# Access Compliance Report

## Public Rights-of-Way

Intersection ID: 3114	Main Street: BROWNESTONE_VIEW_DR	Cross Street: RIDGELINE_LN	Location:	S
ADA ID: 1887385FD7DB	Ramp Type: PerpDiag	Initial Pass/Fail: Fail	Overall Compliance: No	Severity Score: 10
Codes/Mitigation Info/Possible Solution		Field Measurements/Component Compliance

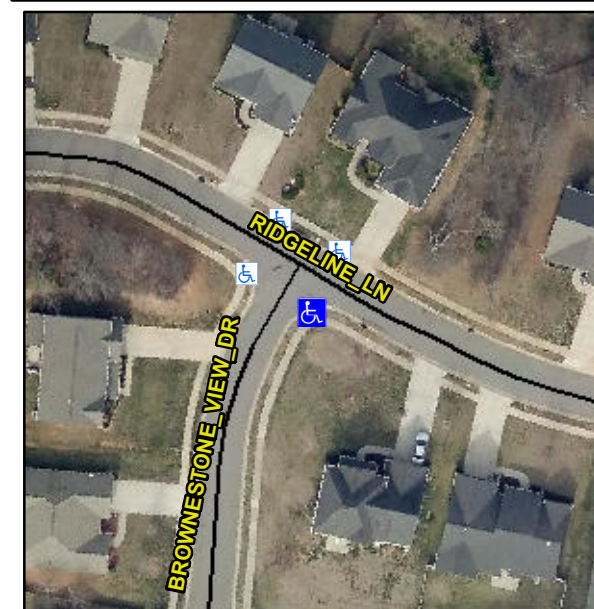
**Not Found, R304.5.1, R304.5.3**

Compliance	Description	Data	Compliance	Description	Data
N/A	Ramp Length (in)	47.5	Yes	Ramp Slope (%)	5.5
No	Ramp Width (in)	45.0	No	Ramp XSlope (%)	4.0
N/A	Flare Type LT	N/A	N/A	Flare Type RT	N/A
N/A	Flare Slope LT (%)	N/A	N/A	Flare Slope RT (%)	N/A
N/A	Flare Traversable LT?	N/A	N/A	Flare Traversable RT?	N/A
N/A	Landing Length (in)	N/A	N/A	DWS Provided?	N/A
N/A	Landing Width (in)	N/A	N/A	DWS Contrast?	N/A
N/A	Landing Slope (%)	N/A	N/A	DWS Length (in)	N/A
N/A	Landing X Slope (%)	N/A	N/A	DWS Full Width?	N/A
N/A	Landing Curb? (Y/N)	N/A	N/A	DWS Offset (in)	N/A
N/A	Shared Landing?	N/A			
N/A	Gutter Ponding?	N/A	N/A	Gutter Slope (%)	N/A
N/A	Gutter Lip Ht (in)	N/A	N/A	Gutter X Slope (%)	N/A
N/A	Painted X Walk1?	No	N/A	Painted X Walk2?	No
	X Walk 1 Direction	To NE		X Walk 2 Direction	To NW
N/A	X Walk 1 Width (in)	N/A	N/A	X Walk 2 Width (in)	N/A
	X Walk 1 Slope (%)	5.0		X Walk 2 Slope (%)	0.1
	X Walk 1 X Slope (%)	0.6		X Walk 2 X Slope (%)	5.6

**Remove & Replace Curb Ramp With Two New Directional Ramps or Equivalent.**
